Planning Reference: 201853

Subject: Brunel Retail Park Rose Kiln Lane Reading

We write in response to consultee response letter to the Reading Borough Council regarding the surface water drainage strategy.

Appendix A – Updated Drainage Layout for Both Phases

First Issue Date	Drawn By	Scale	Checked
JUN'21	RS	1:500	MR
Drawing Number			Rev.
20-043/301			I2

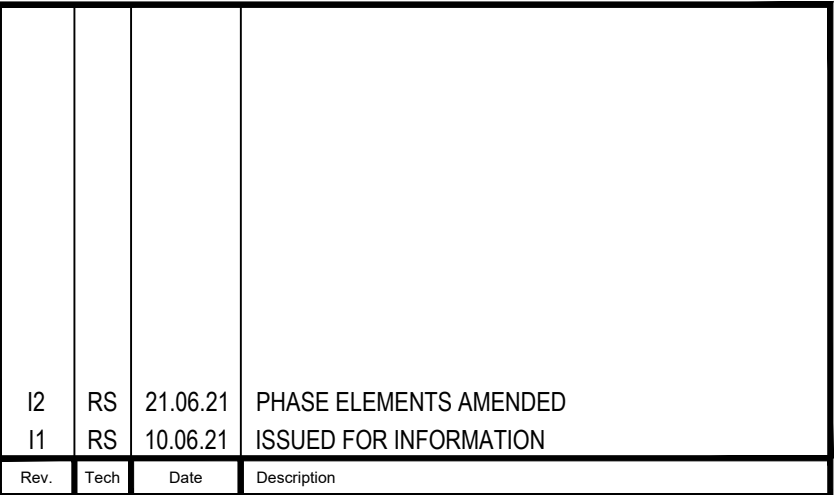
Query: *Drawings have been submitted that illustrates a phase 1 and phase 2 proposal however the phase 1 proposal does not take into account the retention of the existing kerb line along the internal spine road. The road in question is closer to the Unit A as part of phase 1 but the road alignment is altered as part of phase 2 and as such this will alter the drainage scheme and*

therefore must be reflected within the proposals. I have provided images of the two phases below for reference.

Response: The drainage layout has been updated as per phasing layout (Appendix A). The plans are at strategic level. The detailed design process will take account of any further amendments that may be required to provide appropriate drainage along the interface between two phases.
